RISO, INC. **PARTS CHANGE INFORMATION**

PART: SEPARATOR RELEASE LEVER **ISSUE #: 068**

NEW PART NUMBER:011-13311-106 NEW DESCRIPTION: RELEASE LEVER OLD PART NUMBER: 011-13311-009 OLD DESCRIPTION: RELEASE LEVER	[ ] New [X] Modified [ ] Obsolete [ ] Other
Compatible: [ ] Not Compatible: [X] Old/Obsolete: [ ]

RELEASE LEVER P/N 011-13311

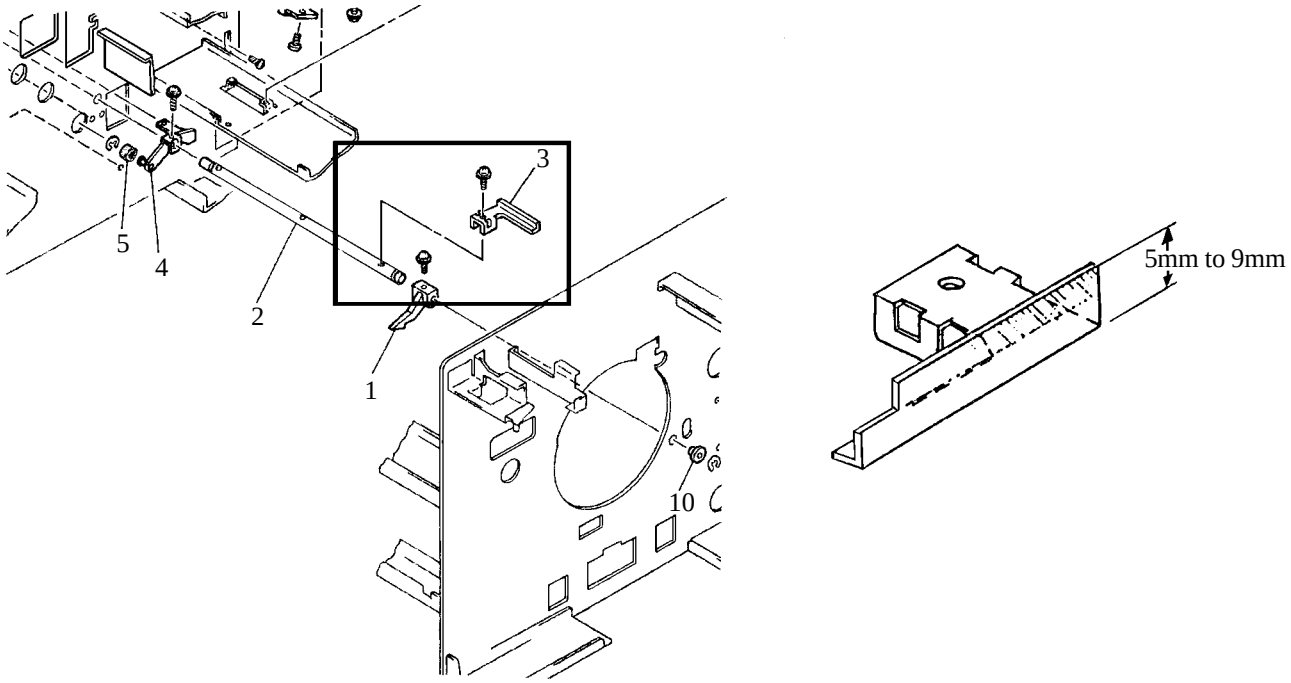
The height of the part that is inserted into the hole of the machine's Side Frame has been changed from 5mm to 9mm.

To prevent the Separator from coming in contact with the Transfer Belt when it is pushed off the surface of the Cylinder by the cam on the Cylinder Body Support (left) during operation.

The modified Release Lever is available as a spare part in the field.
